Fitment Update for the Ultima® Softail® Billet Primary Belt Drives

The updated kits (58-800, 58-801, 58-700, 58-730) will now fit Softail models between the years 1990-2006 (and custom applications) using either an Evo or a Twin Cam[®] motor. We designed the motor plate to accept the fixed distance found between the late model Twin Cam[®] motors and transmission. This is achieved by modifying the shaft housing center to center distance in the motor plate. Since the earlier Evo models use slotted holes in their frames, the transmissions can then be adjusted to fit the new design without any issues. This change affects the following parts; the motor plate, outboard support (if used), and the belt.

How to tell if your belt drive is the new style or the old style:

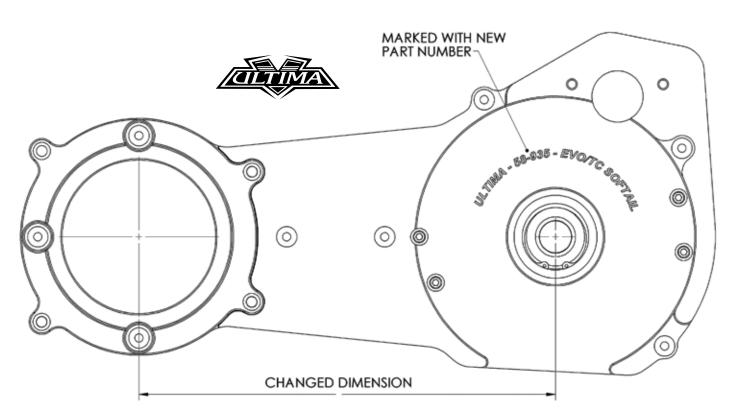
Was your belt drive purchased during or after October 2010? This is when inventory changed. The motorplate, outboard support, and belt are not compatible between the two fitments. Is your motor plate marked with the part number 58-935 (billet) or 58-940 (cast)? This is the new part number for the updated motor plate. All previous motor plates (58-805; billet and 58-705; cast) are not marked.
